Addendum Number 3

Lake Peachtree Spillway Replacement Project

August 4, 2017

PROJECT:	16C17043.00
DATE:	07/10/2017
SHEET	52 OF 66
DATE	
<i>Randall P. Bass</i> GEORGIA PROFESSIONAL ENGINEER NO. 10885 REV. 07/10/17	
 Schnabel ENGINEERING 6445 Shiloh Road, Suite A / Alpharetta, GA 30005 / Phone: 770-781-3003 / Fax: 770-781-3003 / Schnabeleng.com	
DESCRIPTION

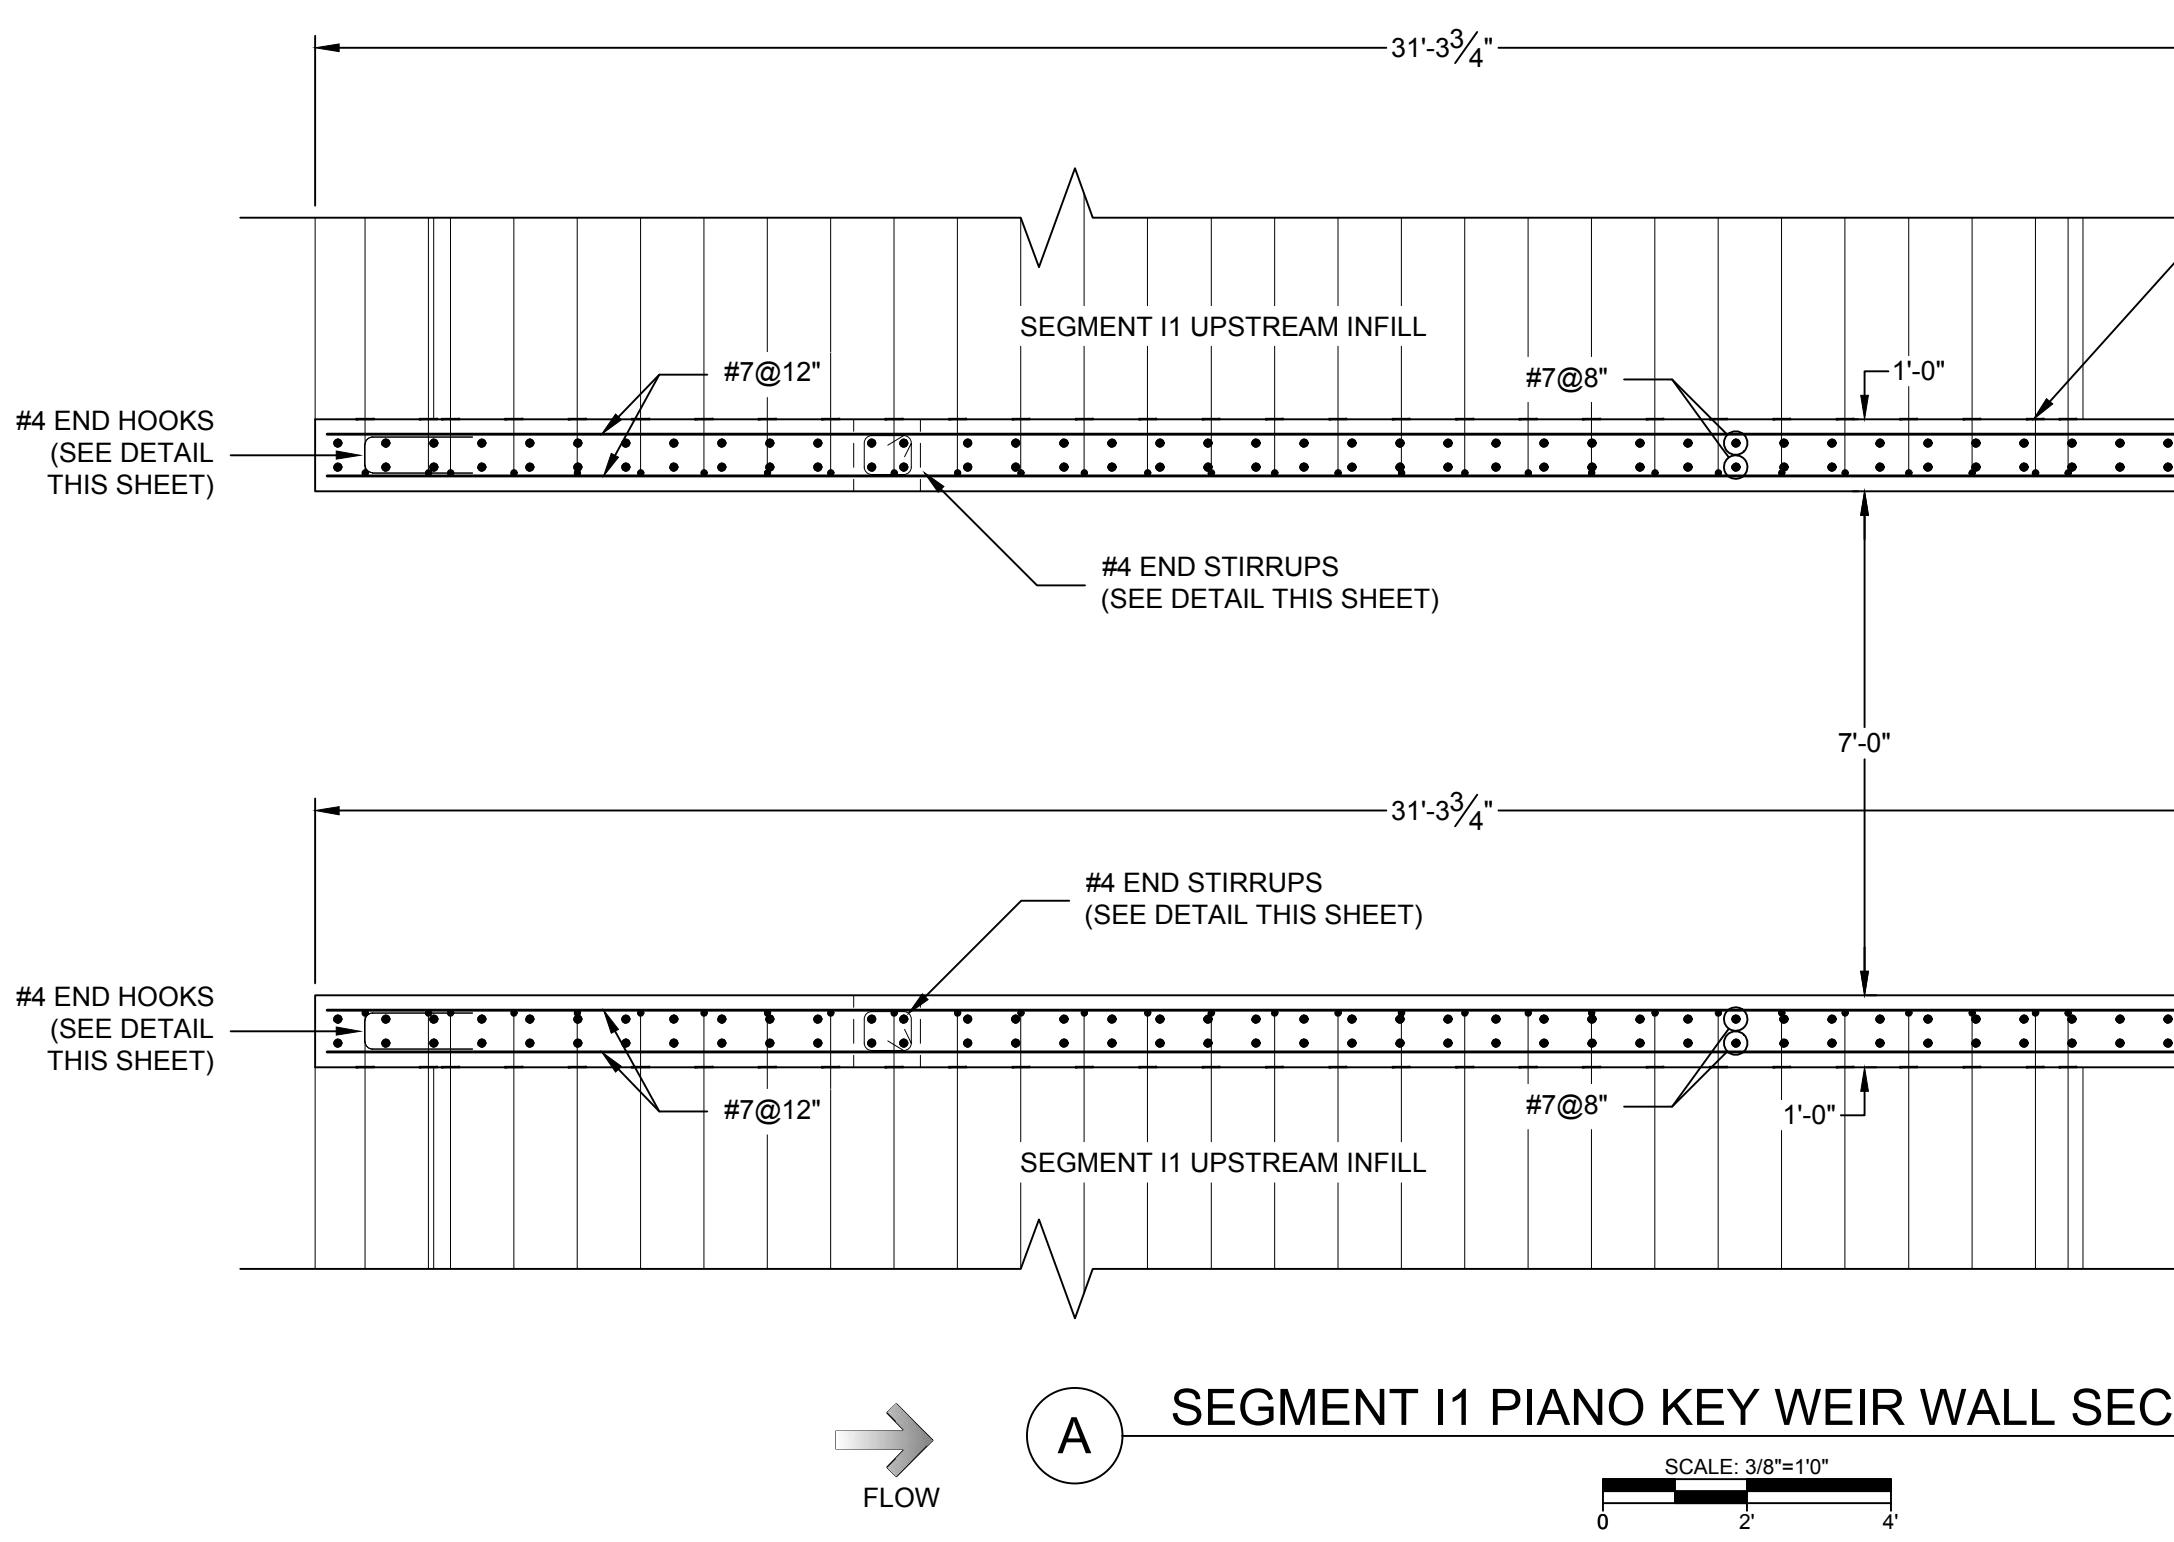
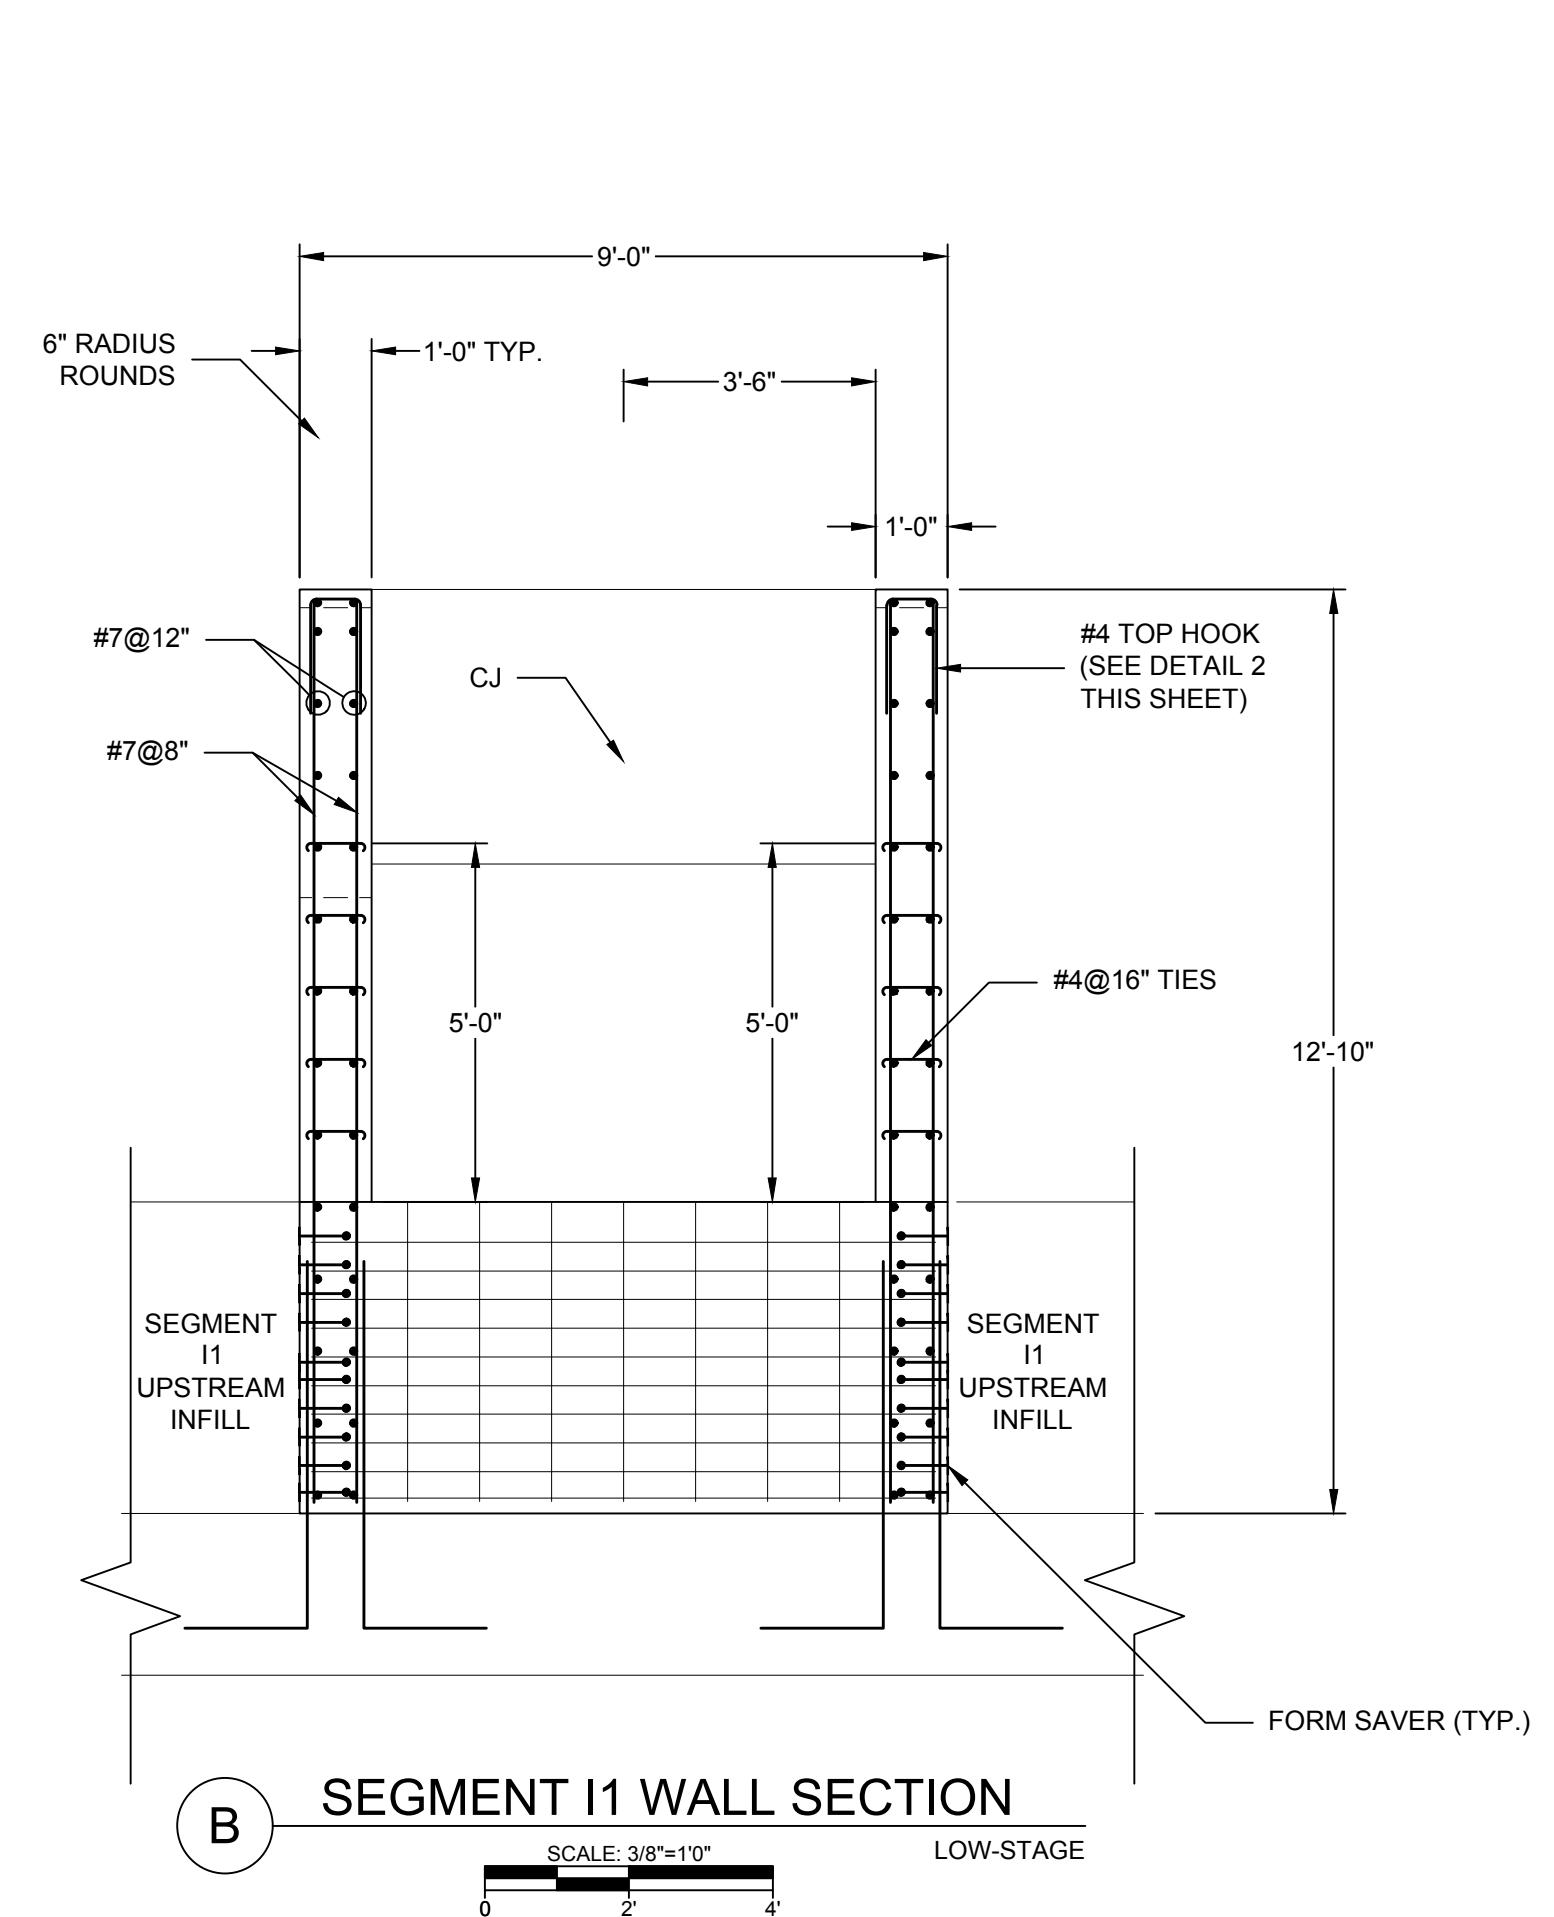
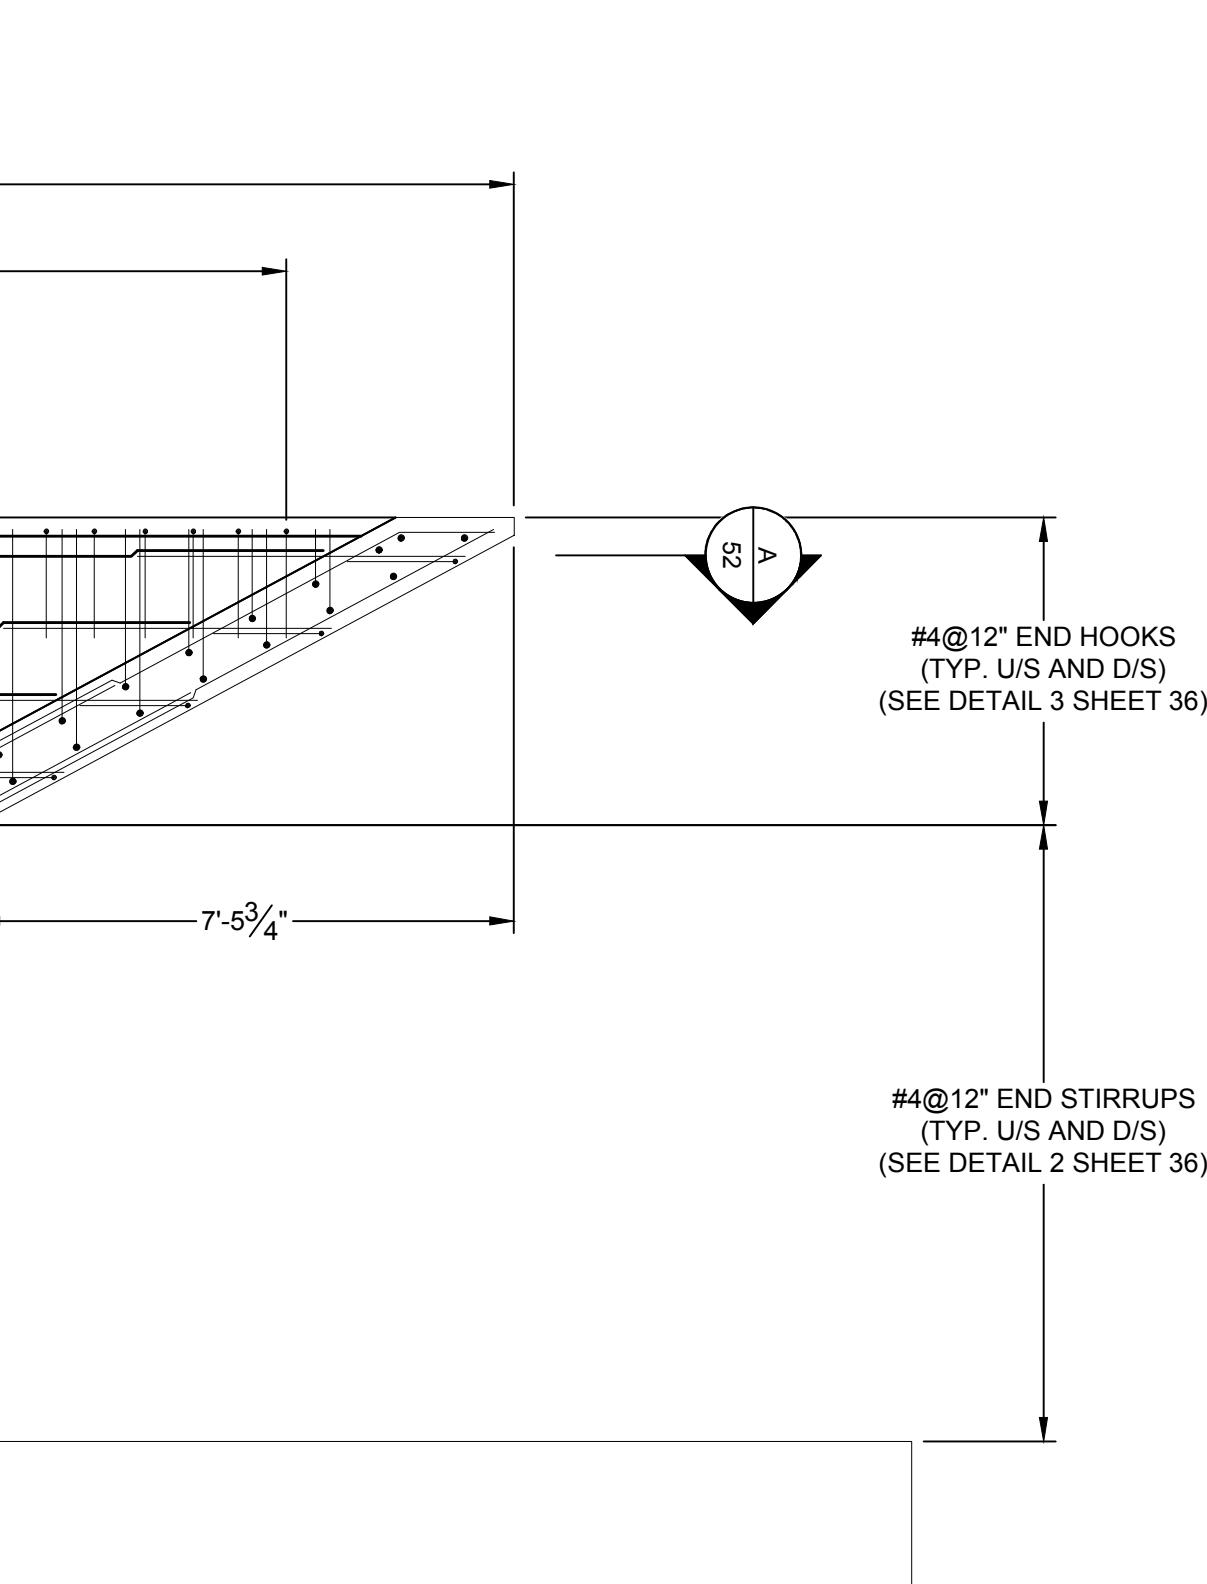
Note: Additional temperature and shrinkage reinforcing steel was added in the ramp/infill sections of the piano key weirs. Sheets with material changes were noted as Revised per Addendum No. 3. Sheets that were inadvertently affected by the changes are included, but do not contain revision clouds/call-outs. The additional reinforcing typically includes the addition of #5@12" spacing, #7@12" spacing, and #4@24" spacing depending on the specific locations of reinforcing.
